## Product Bulletin

**Date:** 10.21.16      **Contact Number:** 734-384-7830  
**Bulletin #** WLK102116      **Contact Name:** Walker Technical Support

**Part Number(s):** 16581      **Application:** 11-10 Chevrolet Equinox / GMC Terrain w/2.4L Eng.

**Product Name:** Walker Ultra Direct-Fit Converter

**Inlet Cone Revised to  
Improve Fatigue Strength**

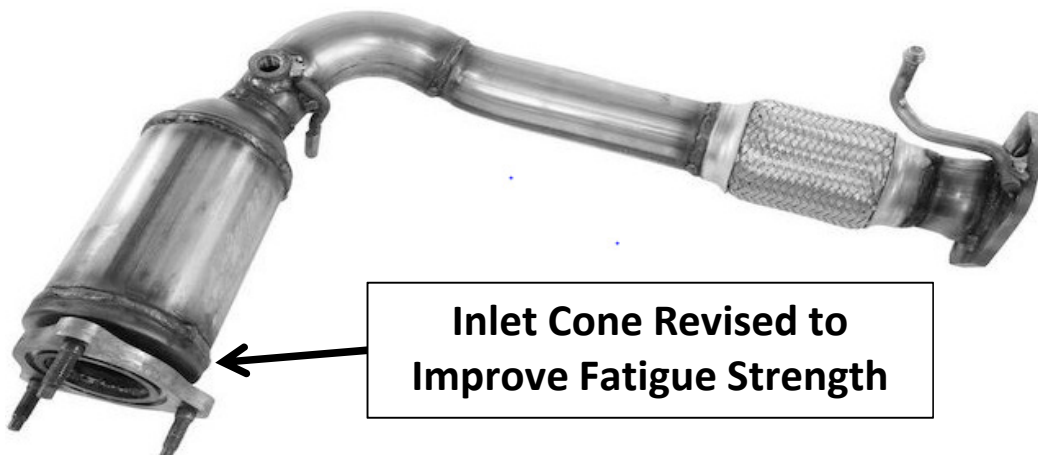
The inlet flange may have the potential to fatigue and crack at the inlet cone if the engine motor mounts are worn.

A design improvement was implemented to improve the fatigue strength of the inlet cone. Parts built with date code 0916116 or later will have the revised design.
